Location of Construction: 77 Mead Street 04103 Owner: Rev. Richard Roos Cheverus High School Phone: 774-7224 Business Name:	Permit No.: 991098 PERMITTED Permit Issued: OCT 4 1999 CITY OF PORTLAND	Lessee/Buyer's Name: N/A Phone:	Zone: CBL: 141-J-012 Zoning Approval:
Contractor Name: Mr. John J. Hills Glenwood Bldg. & Remodeling, 36 Riggs St. Fld., ME Phone: 774-7990	COST OF WORK: \$ 3,000 PERMIT FEE: \$ 42.00	FIRE DEPT. <input type="checkbox"/> Approved <input type="checkbox"/> Denied	Special Zone or Reviews: <input type="checkbox"/> Shoreland <input type="checkbox"/> Wetland <input type="checkbox"/> Flood Zone <input type="checkbox"/> Subdivision <input type="checkbox"/> Site Plan <input type="checkbox"/> Major <input type="checkbox"/> Minor <input type="checkbox"/>
Past Use: 1-Family	Signature: <i>John J. Hills</i> PEDESTRIAN ACTIVITIES DISTRICT (P.A.P.) Action: <input type="checkbox"/> Approved <input type="checkbox"/> Approved with Conditions <input type="checkbox"/> Denied	INSPECTION: Use Group: A3 Type: 57A Signature: <i>John J. Hills</i>	Zoning Appeal: <input type="checkbox"/> Variance <input type="checkbox"/> Miscellaneous <input type="checkbox"/> Conditional Use <input type

FRONT PORCH
77 REND ST.
Portland, Maine

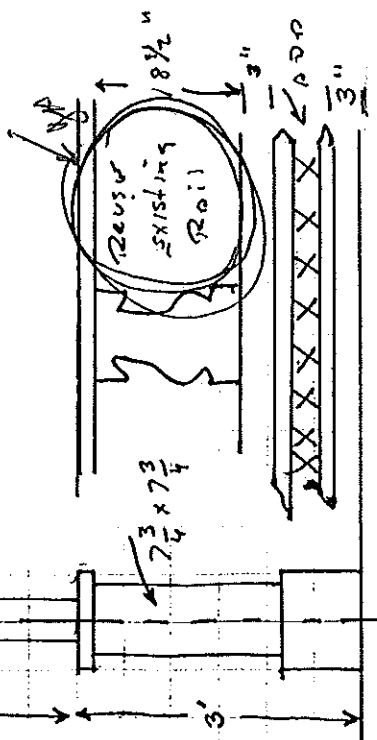
This permit is being issued with the understanding that the following conditions are met: * 1, * 2, * 11, * 13, * 29, * 32, * 33, * 35, * 31

10. Sound transmission control in residential building shall be done in accordance with Chapter 12, Section 1214.0 of the City's Building Code.
11. Guardrails & Handrails: A guardrail system is a system of building components located near the open sides of elevated walking surfaces for the purpose of minimizing the possibility of an accidental fall from the walking surface to the lower level. Minimum height all Use Groups 42", except Use Group R which is 36". In occupancies in Use Group A, B, H-4, I-1, I-2, M and R and public garages and open parking structures, open guards shall have balusters or be of solid material such that a sphere with a diameter of 4" cannot pass through any opening. Guards shall not have an ornamental pattern that would provide a ladder effect. (Handrails shall be a minimum of 3e4" but not more than 38". Use Group R-3 shall not be less than 30", but not more than 38".) Handrail grip size shall have a circular cross section with an outside diameter of at least 1 1/4" and not greater than 2". (Sections 1021 & 1022.0) - Handrails shall be on both sides of stairway. (Section 1014.7)

12. Headroom in habitable space is a minimum of 7'6". (Section 1204.0)
13. Stair construction in Use Group R-3 & R-4 is a minimum of 10" tread and 7 3/4" maximum rise. All other Use Group minimum 11" tread, 7" maximum rise. (Section 1014.0)
